**Lancaster County School District**  
**Amendment #1**

Solicitation Number	202312
Amendment Issue Date	12/7/2022
Solicitation Issue Date	11/18/2022
Procurement Officer	Trevor Hammond, NIGP-CPP, CPPB
Phone	(803) 416-8828
E-Mail Address	Procurement@lcsd.k12.sc.us

**DESCRIPTION: Custom Bally Walk-In Cooler & Freezer Units for Multiple School Locations**

**Questions From Offerors - Amendment**

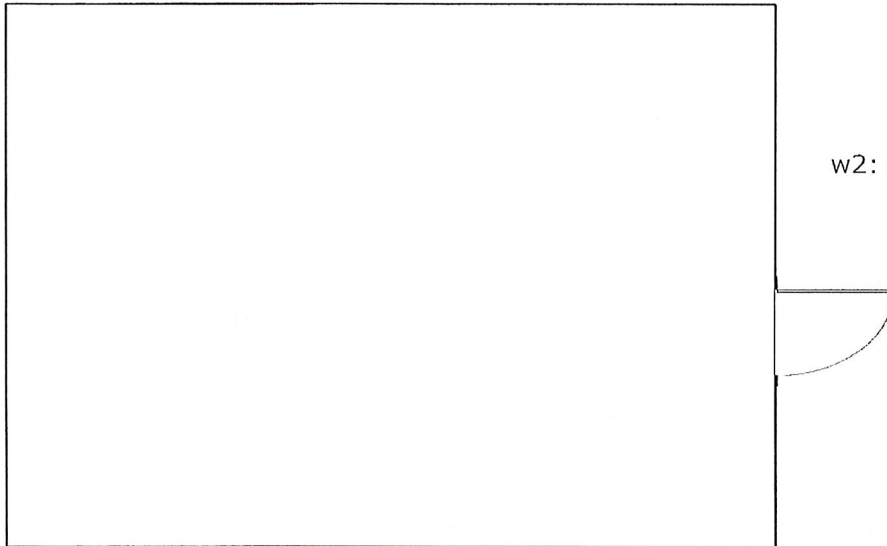
**Question #2:** South Middle School-The small box needs the floor removed and the door needs to shrink to a 30” wide door. Shelving may need to be adjusted.

**Revision 1:** Attachment E-5 has been amended to reflect the removal of the floor and the change to the door dimensions. Attachment E-5 shall be replaced with “Attachment E-5, Amended.” Attachment E-5, Amended is attached to this Amendment document for reference.

**The specifications of the Single Compartment Indoor Cooler Unit at South Middle School shall now be amended to remove the floor of the unit and change the dimensions of the door to 30” wide. The shelving specifications shall remain the same for this unit.**

DOOR 1: Wall2 30" x 78" Hinged Door In a 46" Centered Hinge:Right Orientaion:Regular
